### PIC32MX1XX/2XX/5XX 64/100-pin Family Silicon Errata and Data Sheet Clarification

The PIC32MX1XX/2XX/5XX 64/100-pin family of devices that you have received conform functionally to the current Device Data Sheet (DS20006624AC), except for the anomalies described in this document.

The following typographic corrections and clarifications are to be noted for the latest version of the device data sheet (DS20006624AC):

## 17. Module: Flash Memory Reference: M32S-245

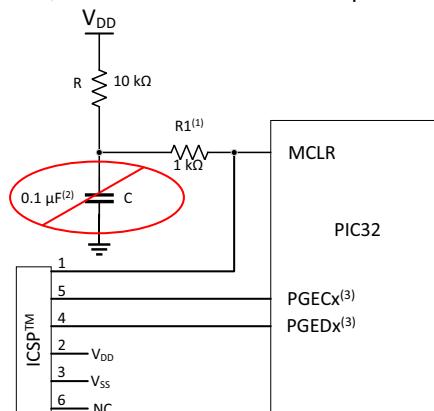
On power up, the internal Flash memory contents may be corrupted if MCLR is active before BOR event is reached. Either or both of the following workarounds may be required to prevent this issue.

If, not using an external reset supervisor IC or equivalent, remove the MCLR capacitor as shown below, and retain the MCLR Pull-up resistor.

If using an external reset supervisor IC or equivalent, increase the value of the VCAP capacitor to  $\geq 47 \mu\text{F}$  ceramic or solid tantalum capacitor with an ESR  $\leq 1 \Omega$ .
